SUBJECT: Forwards response to addl info re ASME Section XI relief for volumetric weld testing of selected RCS branch connection welds.

Donald C. Cook Nuclear Plant Units 1 and 2
ASME SECTION XI RELIEF FOR REACTOR COOLANT SYSTEM BRANCH
CONNECTION WELDS ADDENDUM

RESPONSE TO A REQUEST FOR INFORMATION
ASME SECTION XI RELIEF
FOR VOLUMETRIC WELD TESTING
OF SELECTED RCS BRANCH CONNECTION WELDS

Figure 1
(Note: Figure Not to Scale)

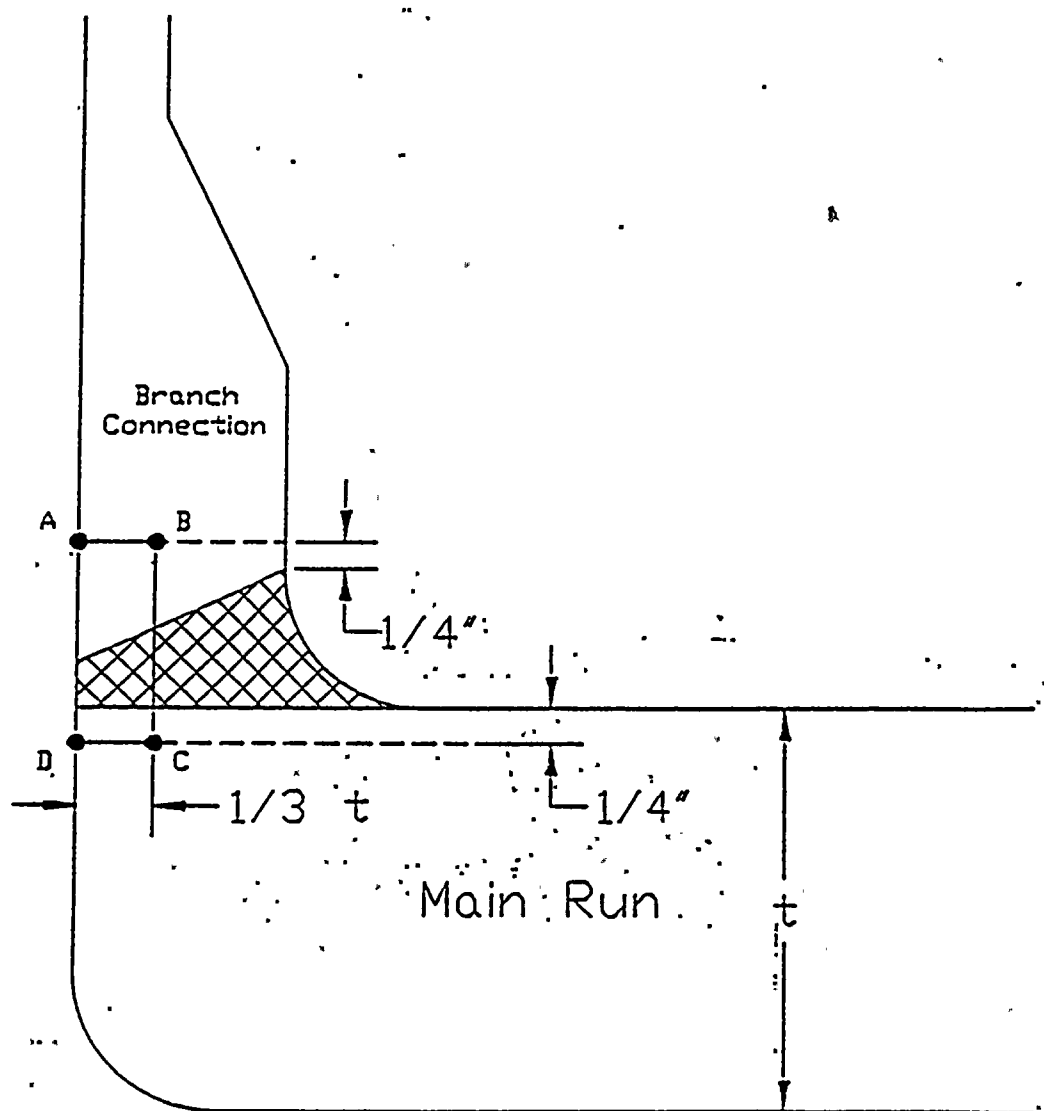
Provide a discussion of the examination results, examination techniques, weld examination coverage and direction of coverage.

In September of 1995, during the last refueling outage of the second 10-year ISI interval for Cook Nuclear Plant Unit 1, three branch connection welds were volumetrically examined, using techniques and procedures based on standard industry methodology, by our vendor Southwest Research.

The RCS branch connections are composed of type 316 stainless steel forged nozzles attached to centrifugally cast stainless steel reactor coolant system piping. The acoustic properties of forged type 316 stainless steel nozzles are excellent while the attenuation characteristics of centrifugally cast stainless steel piping make it extremely difficult to perform an adequate examination from the reactor coolant system piping. Furthermore, the set-on nozzle arrangement with the weld orientation normal to the branch pipe axis precludes weld examination coverage from the reactor coolant piping using code calibration techniques. For these reasons, the examination was conducted from the branch pipe surface adjacent to the weld seam (Appendix III-4100). The code required volume is illustrated in Figure 1 and Table 1 summarizes the techniques, and essential parameters for these examinations. In summary, the ultrasonic examination meets the scan coverage requirements of the 1983 edition of ASME Section XI, through Summer 1983 addenda for reflectors parallel to the weld seam (Appendix III-4420) and for reflectors transverse to the weld seam (Appendix III-4430) with limitations noted in Table 1 (attached). No recordable indications other than geometric reflectors were reported during these examinations.

Angle beam examinations were conducted from branch pipe side only.

SWRI procedure DCC-UT56, Rev 0, Chg. 0 was used for the examination of RCS branch piping welds. Sound transmission and examination volume coverage limited on transverse angle beam technique due to weld configuration and pipe geometry. Examined to the extent possible.
